# **P802.3ck D3.0 Comment Resolution Clause 162**

Howard Heck, Intel  
Chris Diminico, MC Communications/PHY-SI LLC/Panduit

Figure 162-5—NSD(f) constraints

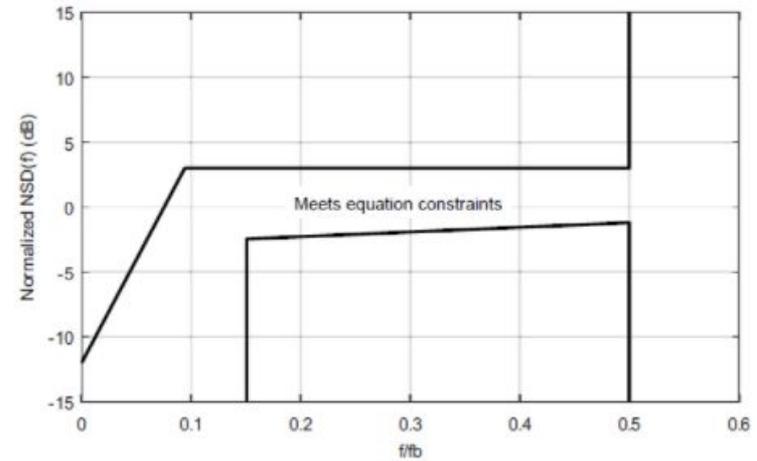
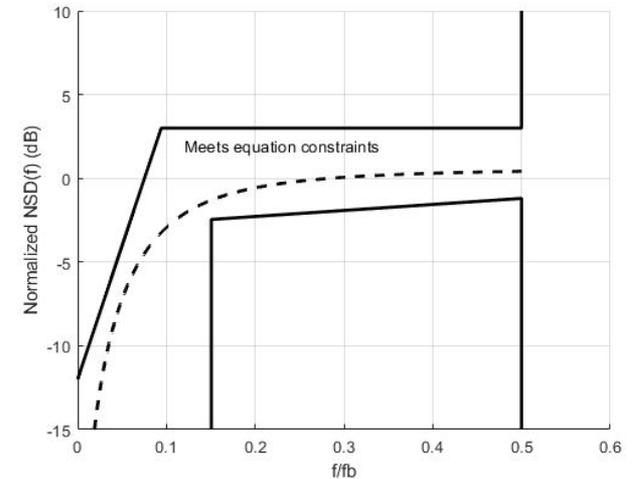
Please add the plot of Hhp, squared and normalized, to Figure 162-5, NSD(f) constraints. See example in attached file.

PROPOSED REJECT.

The comment does not provide sufficient justification to support the proposed changes. The proposed change does not improve the clarity or accuracy of the standard. In fact, the proposed change detracts from the intent of the figure. For task force discussion.

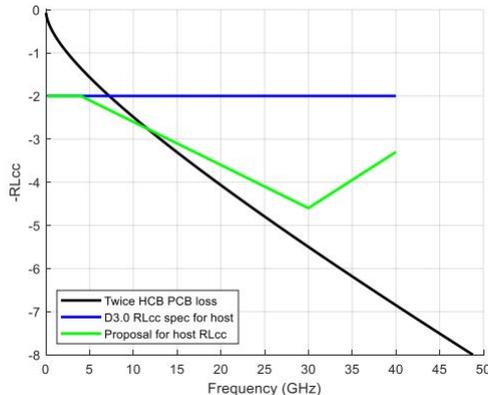
As for the mated test fixtures and the cable, this common mode return loss spec RLcc becomes useless at the frequency when the MCB loss is 2/2 dB, which is only 10 GHz. The spec should trend down with the MCB trace loss at 0.1 dB/GHz.

Use a frequency-dependent mask  $2 \text{ dB } 0.2 \leq f \leq 4$ ,  $1.6+0.1 \cdot f \text{ dB } 4 < f \leq 30$ ,  $8.5-0.13f$   $30 < f \leq 40$ . f is in GHz. See another comment for cable RLcc, 162.11.6.

PROPOSED REJECT.  
 The suggested remedy does not provide data or analysis to demonstrate that the proposed mask is sufficient.  
 For task force discussion.

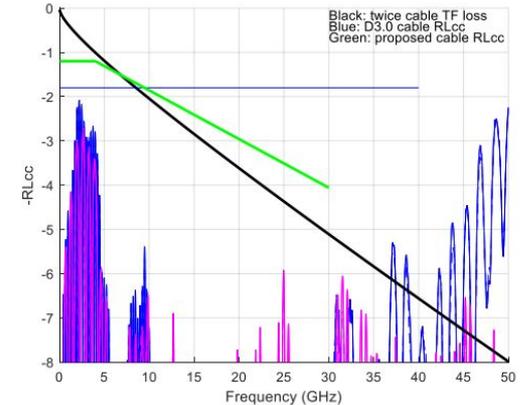
We need a common mode return loss spec RLcc to stop large common-mode voltages building up through multiple low-loss reflections. As we know, this common mode return loss spec RLcc becomes useless at the frequency when the MCB loss is 1.8/2 dB, which is only 8.5 GHz. The impedance the cable presents is mostly related to the connector, so it's much like the mated test fixtures' RLcc, except at the very lowest frequencies where the cable loss is very small and both connectors can be seen by the measurement. This proposal allows for that.

Use a frequency-dependent mask  $1.2 \text{ dB } 0.05 \leq f \leq 4$ ,  $0.76+0.11 \cdot f \text{ dB } 4 < f \leq 30$  GHz. f is in GHz. See another comment for Tx, Table 162-11, 162.9.3.6.

PROPOSED ACCEPT IN PRINCIPLE. Although the comment does not provide sufficient evidence to support the proposed remedy. It does provides a better fit to posted CA measurements and merits consideration on that basis. For committee discussion.

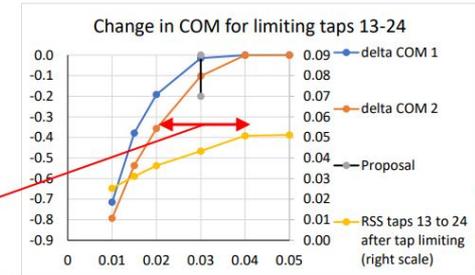
We can expect cable channels to be better for reflections than backplane channels because hosts must be designed for maximum-loss performance, and cable technology will also be adequate for maximum-loss performance. As a cable can have worse tap weights than the headline numbers for a very small COM penalty (see daw\_e\_3ck\_01a\_0921 slide 5), this remedy leaves margin for the cable.

For CR, in Table 162-19, change Normalized coefficient magnitude limit for DFE floating taps, bgmax, from 0.05 to 0.03.

PROPOSED ACCEPT.

Dawe\_3ck\_01a\_0921 addresses potential impact of tighter limits for tap positions 13-24.

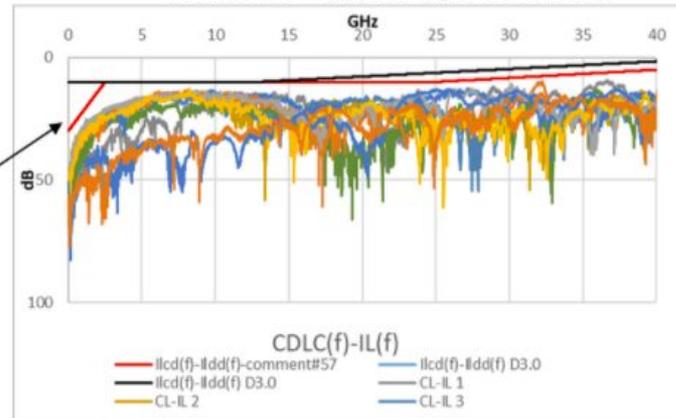
Change equation 162-19 limit to be  
 $24 - 13.56/f * 14 \mid 0.05 \leq f \leq 13.56$   
 $10 \mid 13.56 \leq f \leq 40$

Change Figure 162-9 accordingly.

Change equation 162-19 limit to be  
 $30 - 8f \mid 0.05 \leq f \leq 2.5$   
 $10 \mid 2.5 \leq f \leq 25$   
 $10 - (f-25)/3 \mid 25 \leq f \leq 40$

Change Figure 162-9 accordingly.

**PROPOSED REJECT.**

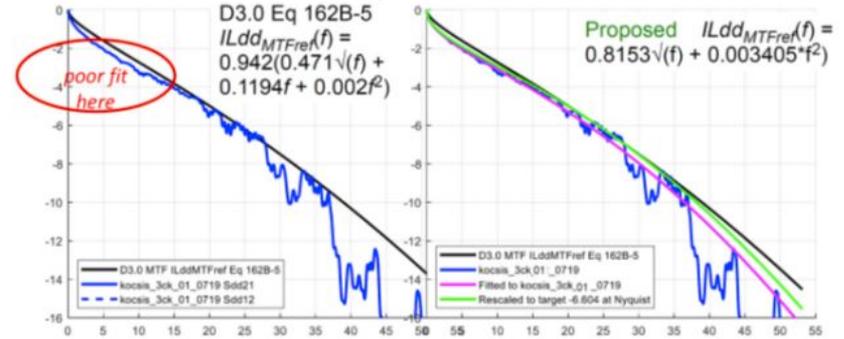
The reference differential-mode to differential-mode insertion loss of the mated test fixture is a scaled version of Eq 120E-3 and it doesn't align well to kocsis\_3ck\_01\_0719, slide 4. This causes a problem when constructing the lossy channel for the module stressed input test (in daw\_3ck\_01a\_1121 slide 8, the green line is straighter than the black line at low frequencies). The new equation has the same loss at Nyquist as the existing one. See new presentation.

Change equation 162B-5 from:  
 $ILdd_{MTFref}(f) = 0.942(0.471\sqrt{f}) + 0.1194f + 0.002f^2$   
 to  
 $ILdd_{MTFref}(f) = 0.8153\sqrt{f} + 0.003405f^2$   
 Update Figure 162B-3, Mated test fixtures differential-mode to differential-mode insertion loss

Proposed Response Response Status W  
 PROPOSED ACCEPT IN PRINCIPLE.  
 For committee discussion of presentation
